Access Compliance Report

Public Rights-of-Way

(Curb Ramps)

Intersection ID: 45182	Main Street: MAPLEHURST_DR	Cross Street: SOCIETY_ST	Location: SE
ADA ID: 27FAD88D4A10	Ramp Type: Perp	Initial Pass/Fail: Fail	Overall Compliance: No
Codes/Mitigation Info/Possible Solution		Field Measurements/Component Compliance	
Severity Score: 12.5

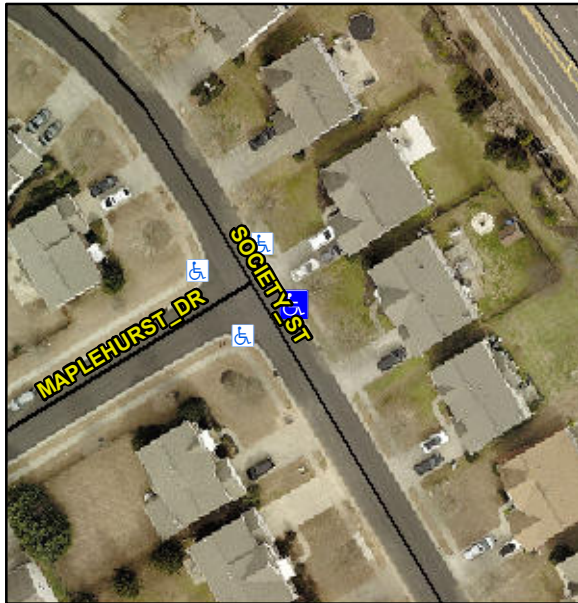
PROW/ADA:

Not Found, R304.2.2

Compliance	Description	Data	Compliance	Description	Data
N/A	Ramp Length (in)	47.0	No	Ramp Slope (%)	11.4
Yes	Ramp Width (in)	49.0	Yes	Ramp XSlope (%)	1.3
N/A	Flare Type LT	N/A	N/A	Flare Type RT	N/A
N/A	Flare Slope LT (%)	N/A	N/A	Flare Slope RT (%)	N/A
N/A	Flare Traversable LT?	N/A	N/A	Flare Traversable RT?	N/A
N/A	Landing Length (in)	N/A	N/A	DWS Provided?	N/A
N/A	Landing Width (in)	N/A	N/A	DWS Contrast?	N/A
N/A	Landing Slope (%)	N/A	N/A	DWS Length (in)	N/A
N/A	Landing X Slope (%)	N/A	N/A	DWS Full Width?	N/A
N/A	Landing Curb? (Y/N)	N/A	N/A	DWS Offset (in)	N/A
N/A	Shared Landing?	N/A			
N/A	Gutter Ponding?	N/A	N/A	Gutter Slope (%)	N/A
N/A	Gutter Lip Ht (in)	N/A	N/A	Gutter X Slope (%)	N/A
N/A	Painted X Walk1?	No	N/A	Painted X Walk2?	N/A
	X Walk 1 Direction	To SW		X Walk 2 Direction	N/A
N/A	X Walk 1 Width (in)	N/A	N/A	X Walk 2 Width (in)	N/A
	X Walk 1 Slope (%)	3.8		X Walk 2 Slope (%)	N/A
	X Walk 1 X Slope (%)	1.9		X Walk 2 X Slope (%)	N/A

Possible Solutions:

Remove & Replace Entire Ramp.
